**APPENDIX R**

**Comments on the Draft EIS and Responses**

## CO28 continued, page 121 of 302

Figure 10: Pipeline Parallel to and Crossing Spencer Creek and crossing Clover Creek, near Milepost 177

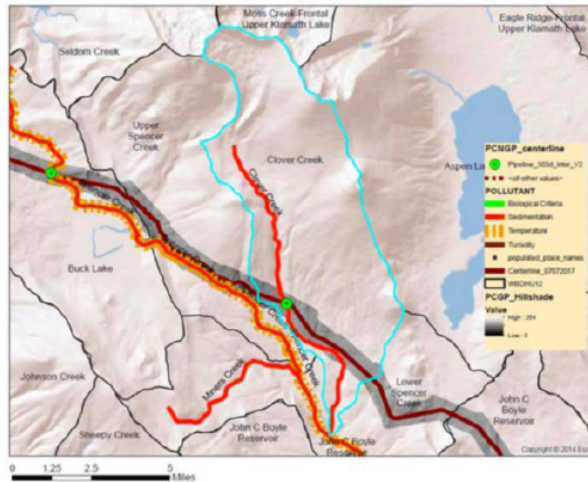
Figure 10 shows one of several examples of the permanent ROW crossing or paralleling streams on the 303(d) list for sediment or crossing streams discharging to these sediment-listed streams. Based on its proposed conceptual approach for operating the ROW, the permanent ROW has the potential to discharge sediment at stream crossings. Ongoing increases in sediment loading to a waterbody that is listed on the 303(d) list for sediment is not allowed without either a TMDL allocation, or an implementation plan showing that there will be no increase in loading. OAR 340-41-0004(7)(c) "Water quality limited waters may not be further degraded except in accordance with paragraphs (9)(a)(B), (C) and (D) of this rule." JCEP has not provided the analyses for the discharges that would occur at each slope breaker for each stream crossing. In addition, JCEP has not performed an analysis to demonstrate that the herbaceous area in the permanent ROW between the last slope breaker and stream is an effective BMP by itself and would not contribute to or cause a water quality standard violation, particularly near waterbodies that are not meeting standards for sediment. As noted in DEQ's September 7 (Page 11 of 15 of, Attachment B) and December 2018 (Page 66 – 68 of Attachment A) information requests, DEQ requested that JCEP evaluate the efficacy of these proposed BMPs using modeling. JCEP has not provided DEQ with this evaluation of the water quality impacts from this slope breaker discharge nor has it provided DEQ with the analysis of the proposed treatment for the discharge from slope breakers immediately upslope of a stream.<sup>355</sup>

CO28-181 See response to comment CO28-164 (which would apply also to right-of-way clearing).
